Woodlawn Bioreactor

Addendum to modification application

Modification of DA 31-02-99 and MP 10_0012 for the construction of a leachate treatment plant and associated infrastructure, and changes to regional waste limits and operating hours

June 2017

Figure 1 – Location of proposed additional storage capacity

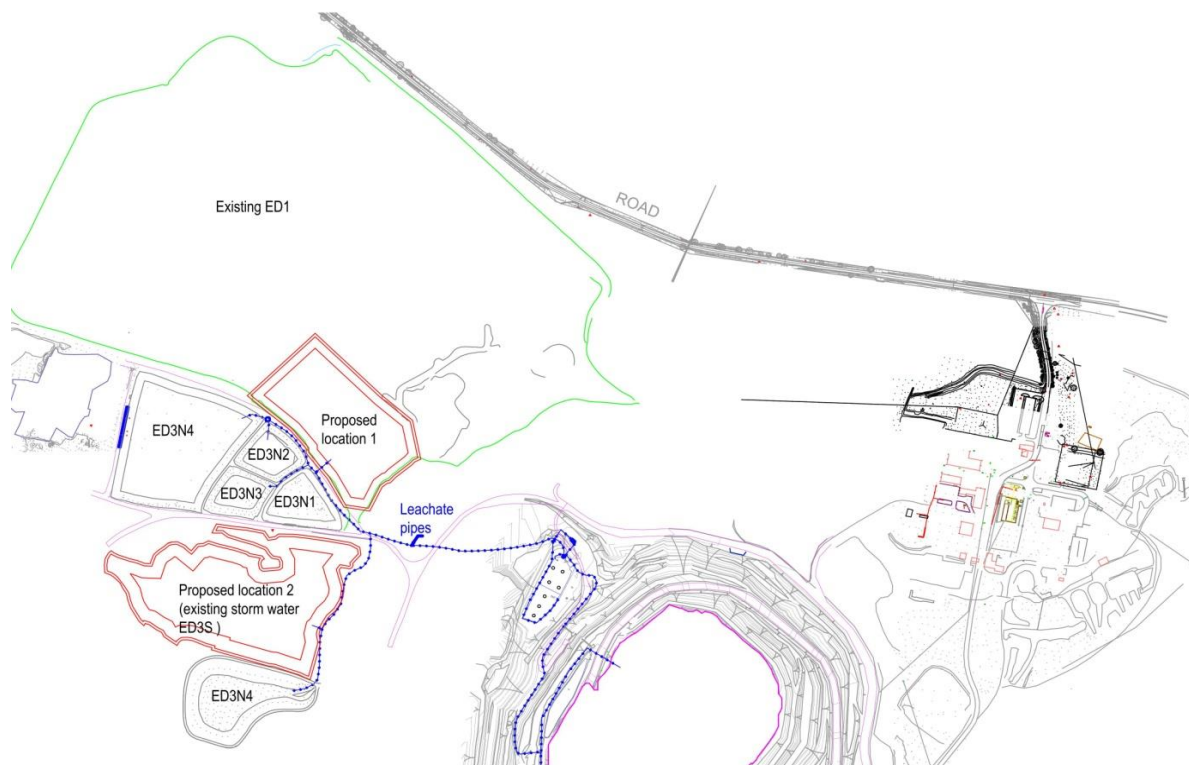
To accommodate the temporary additional storage needs, Veolia proposes to utilise an area within the footprint of ED1 as identified in Figure 1. This are will have a capacity of 150 ML providing sufficient freeboard for the estimated additional 140,576m³ or 140 ML of leachate. The temporary storage facility will be approximately 4.5 ha in area and about 3 m in height and will be situated about 2m above the water table. It will be a standalone storage facility within ED1 and immediately adjacent to the existing leachate storage in ED3.

Given it is located within ED1, minimal excavation is required to create the temporary additional storage capacity. The area will be de-silted before being lined consistent with EPA standards. It will have a clay liner which will be approximately 0.7 to 1 m thick, comprising 2 impervious layers (i.e. insitu clays at $K= 1 \times 10^{-09}$ to 1×10^{-10} m/sec and, imported clays from Holcim site at $K=$ approx 1×10^{-10} m/sec). Final design details including the precise thickness and mix of insitu/exsitu clay materials will be based on the results of site testing, survey and design considerations.

Given that the area will be appropriately lined consistent with contemporary standards, the findings of the recent seepage investigations are not considered specifically relevant.

In summary, this addendum report updates the modification application by seeking approval to pump the additional 140 ML of leachate into the area within ED1, and further to store that leachate in this area and progressively reprocess it through the LTP over a 12 year period. This timeframe reflects an approximate 50% increase in temporary storage capacity and therefore an approximate 50% increase in the time required to process this leachate through the LTP from 8 to 12 years. Beyond this point in time, this area would be utilised for the storage of treated leachate consistent with the long term use of ED1 in the LTLMS.

Figure 2 – Odour contour plot of proposed ED3N-5 individually and cumulatively.

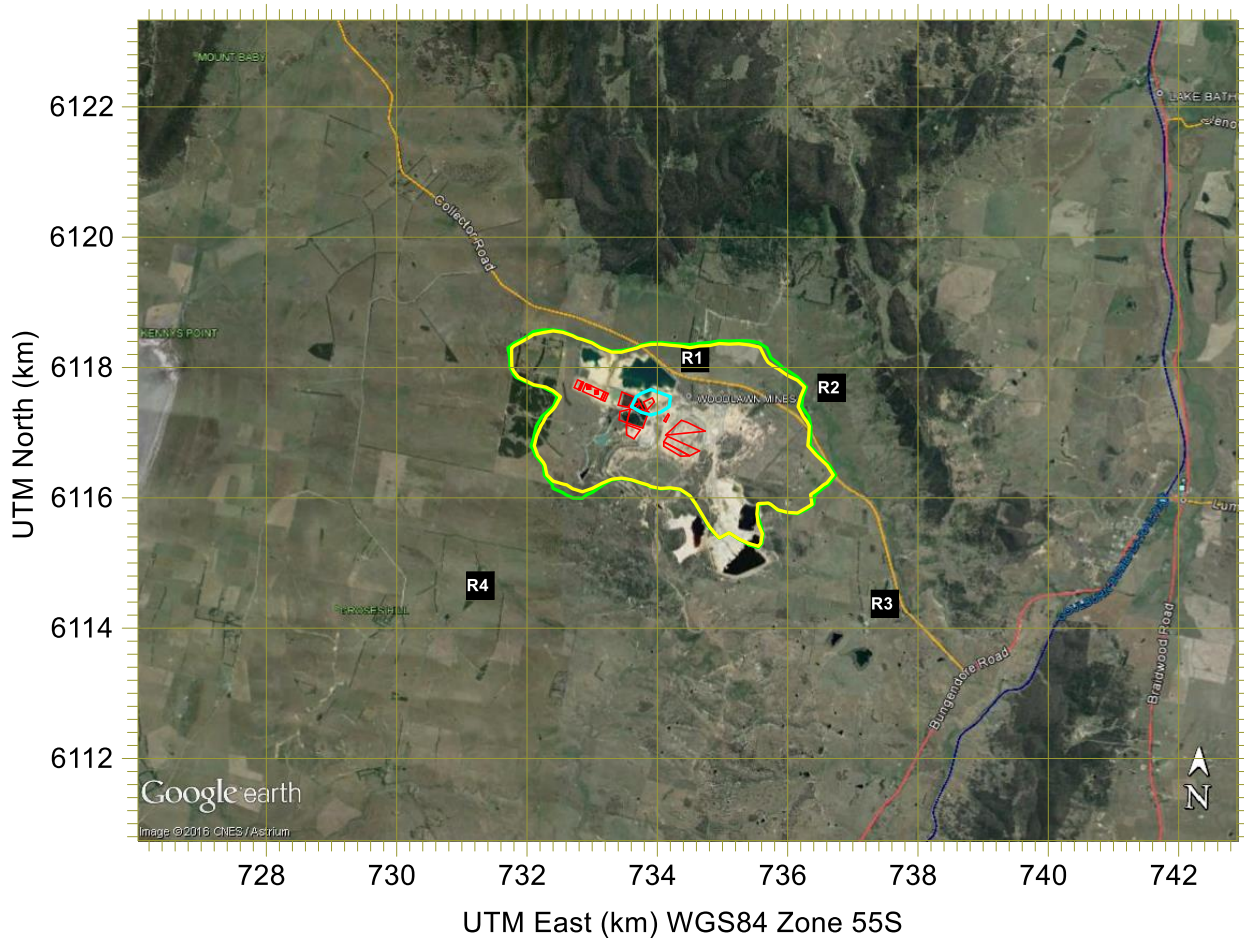
The odour assessment found that there would be a small incremental increase to the overall projected ground level concentrations at nearby receptors and the overall extent of impact area. The findings are similar to the findings and conclusions relevant to the commissioning of the ED3SS system. The assessment, as updated, found that it was unlikely that the small identified increases would be perceivable within the community and that the existing amenity of nearby sensitive receivers would not be affected by the temporary storage of leachate within ED1.

The results of the odour modelling are compared with the previous modelling results as ground level odour concentrations (99%ile, 1s avg) at nearby receptors in **Table 1**. The odour contour plot depicted in **Figure 2**, illustrates the **adopted Impact Assessment Criterion of 6ou (99%ile, 1s avg)** for the proposed ED3N-5 dam individually, and cumulatively compared with the result modelled in the previous study.
